#### **HOLDOVER**

#### Revised

### **ESSEX PLACE SUBDIVISION**

# DETAIL SITE PLAN

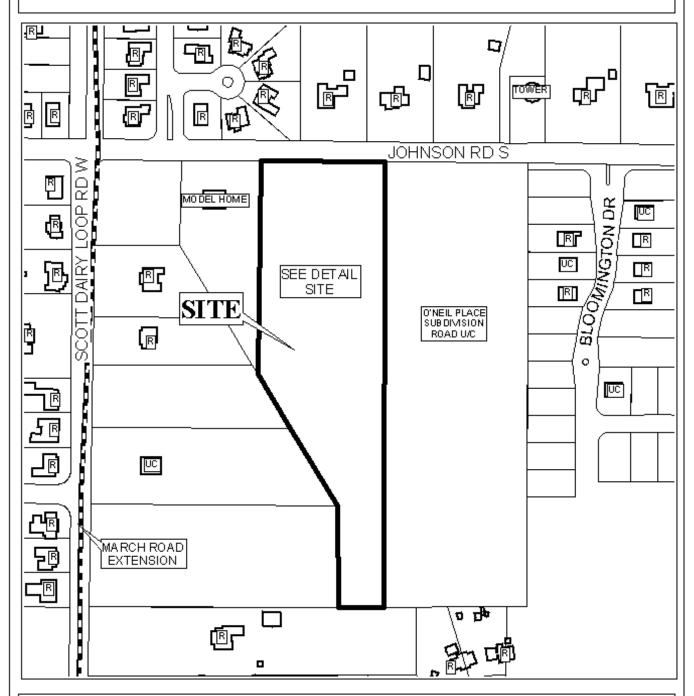
The site fronts Johnson Road, which has adequate right-of-way of 60 feet. The proposal includes the creation of a new street, which will have adequate right-of-way of 50 feet. The new street will be closed-ended and longer than 600', and the site is adjacent to a large undeveloped property to the East; therefore, therefore a street stub to the East should be required, according to Section V.B.1 of the Subdivision Regulations. Corner lots show adequate curb radii of 25 feet, and the turnaround satisfies the 110' diameter requirement.

The 25' minimum building setback lines are shown on the plat. Lot size, width to depth ratio, and frontage are adequate.

The plat meets the minimum requirements of the Subdivision Regulations, and as such is recommended for Tentative Approval subject to the following conditions: 1) the provision of a street stub to the East, per Section V.B.1 of the Subdivision Regulations; and 2) the dedication and construction of the new street to County Engineering standards.
